Addendum 47: Regulation No. 48

Revision 6 – Amendment 9

Supplement 9 to the 04 series of amendments - Date of entry into force: 18 November 2012

Uniform provisions concerning the approval of vehicles with regard to the installation of lighting and light-signalling devices

"Annex 13

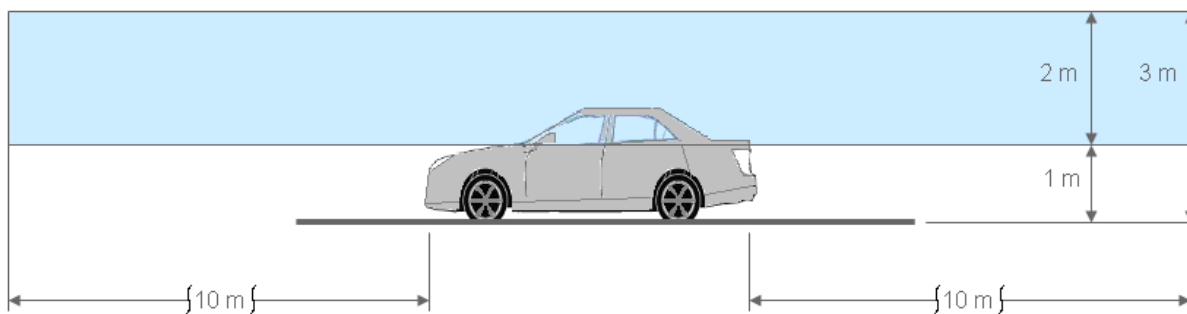
Insert a new Annex 13, to read:

Observing area towards the apparent surface of manoeuvring lamps

Zones of observation

This drawing shows the zone from one side, the other zones are from the front, the rear and from the other side of the vehicle

6.26.9.1. The Technical Service shall, to the satisfaction of the authority responsible for type-approval, perform a visual test to verify that there is no direct visibility of the apparent surface of these lamps, if viewed by an observer moving on the boundary of a zone on a transverse plane 10 m from the front of the vehicle, a transverse plane 10 m from the rear of the vehicle, and two longitudinal planes 10 m from each side of the vehicle; these four planes to extend from 1 m to 3 m above and parallel to the ground as shown in Annex 13.
